Special Bulletin

SP18-304 A

SLIDING DOOR ADJUSTMENT AND HARDWARE REPLACEMENT

Prevost vehicles

Figure 9

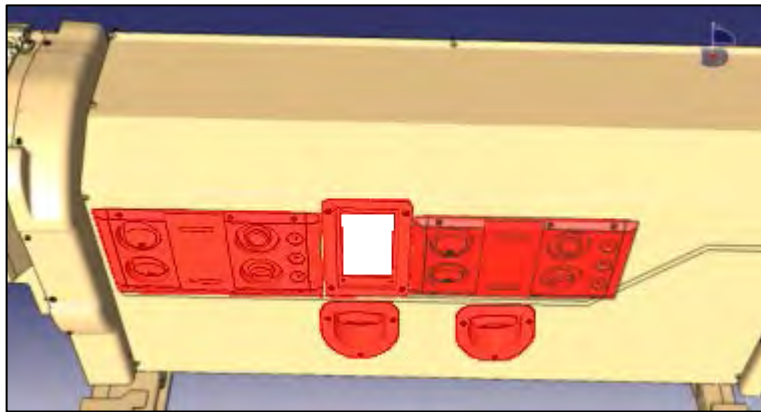
Revision: A Changed *figure 9*. Updated related steps. Time required was 1h, is 2.5h. 2018-06-20

4. Create some working space by removing screws and disconnecting both modules, lights and the ultrasound threshold sensor. Reserve hardware. (Figure 9)
5. The black ground may be hard to disconnect. Use a pair of long nose pliers to help disconnection.
6. Disconnect the main connector of the left hand vent & light module.
